**DATE:** June 9, 2021

<u>Certificate of Appropriateness Request:</u>	H-01-21
<u>Applicant:</u>	Harry and Andrea McKay
<u>Location of subject property:</u>	135 Spring Street NW
<u>Staff Report prepared by:</u>	Katherine Godwin, Sr. Planner

- Applicants are requesting a Certificate of Appropriateness to:
  - Remove two trees;
  - Construct a two-story, two-car, detached garage with covered patio and outdoor kitchen;

PROPOSED SITE PLAN

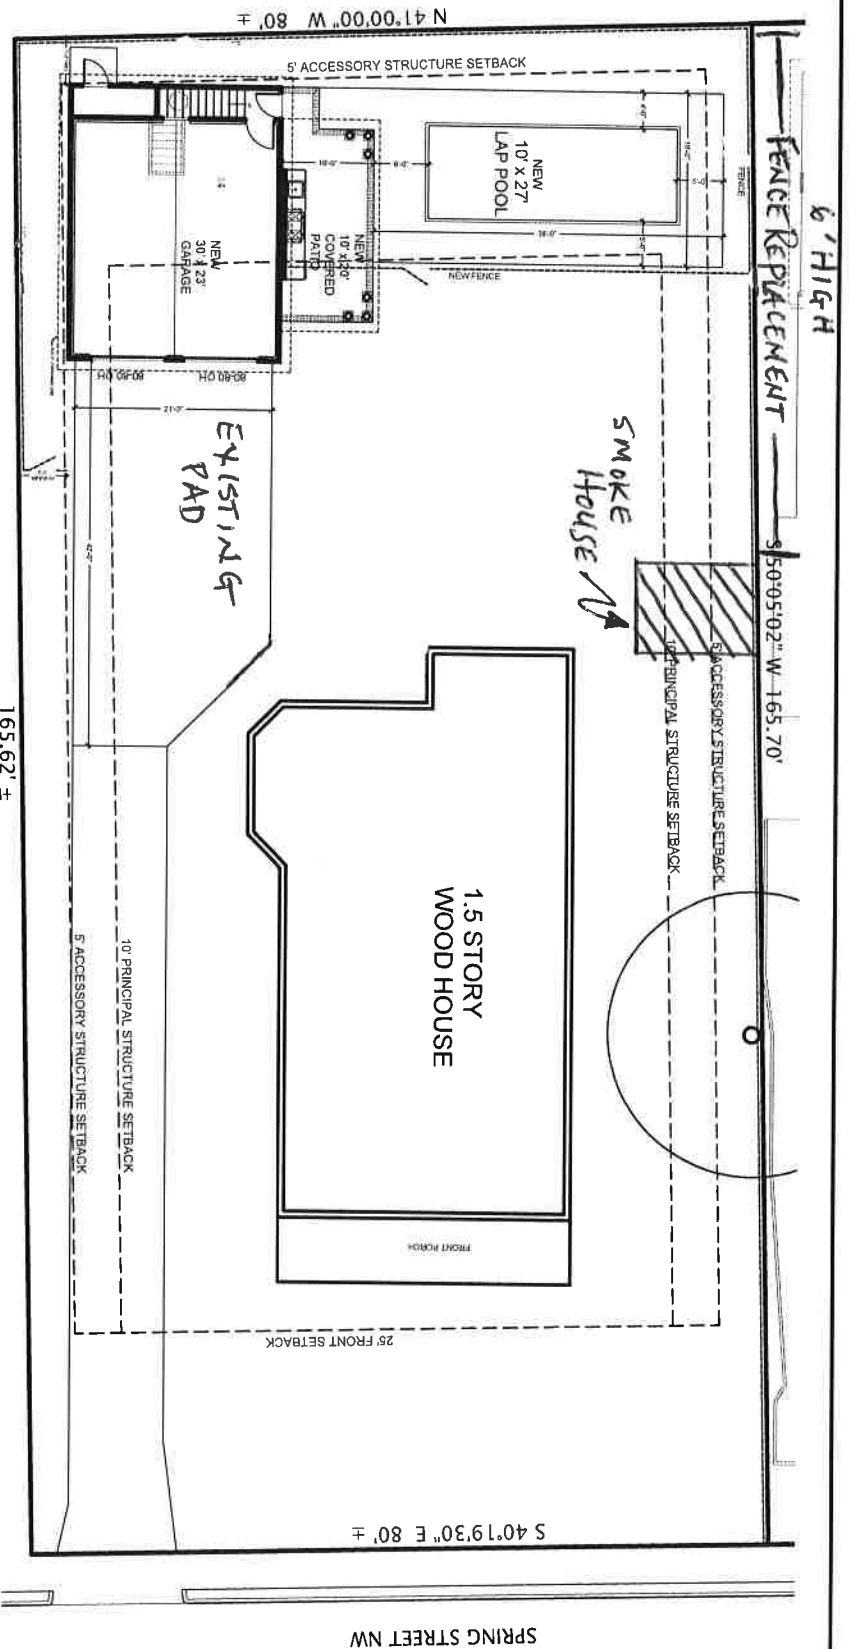
Thanks for this information. So I am working on your site plan cleaning it up for the presentation and have removed the walkway and the label on the parking pad. Can I remove all references to “new fence” and just add “fence replacement”? Can you also please give me an estimate of this length. Also is the smoke house existing or planned (i.e. needs to be part of the application or a new application)? I’ve also edited your signed application to get rid of the replacement tree reference and the neighbor’s limb removal (see attached). Everything else looks good to go. Thanks!

I have clarified Cary's drawing where some text was misleading. Please see the updated site plans and elevations. I have also addressed your concerns with the below:

- There will be no new walkway installed and I have corrected that on the updated site plan attached.
- I have made corrections on the bullet list to the pool dimensions to represent the drawing at 10' X 27'.
- There is a new drawing showing tree removal attached.
- Rather than 2 Dogwoods, we will plan to plant one as well as an Elm for canopy.
- We do not anticipate removing a limb from the neighbors tree. It is 40' off the ground.
- We are REPLACING one short side of the EXISTING wooden stockade fence to match the other 2 sides. It will be an improvement over stockade-style to shadow-box style. It will also be stained Charleston Green to match the rest of the fence. I have clarified that on the drawing.
- The brick over the kitchen elements will not be painted and I have clarified that in the bullet list.

You can duplicate by latest submittal on the site plan. So yes, remove the walkway and label. Remove reference to new parking surface as it already exists. Yes to removing all “new fence” notes.
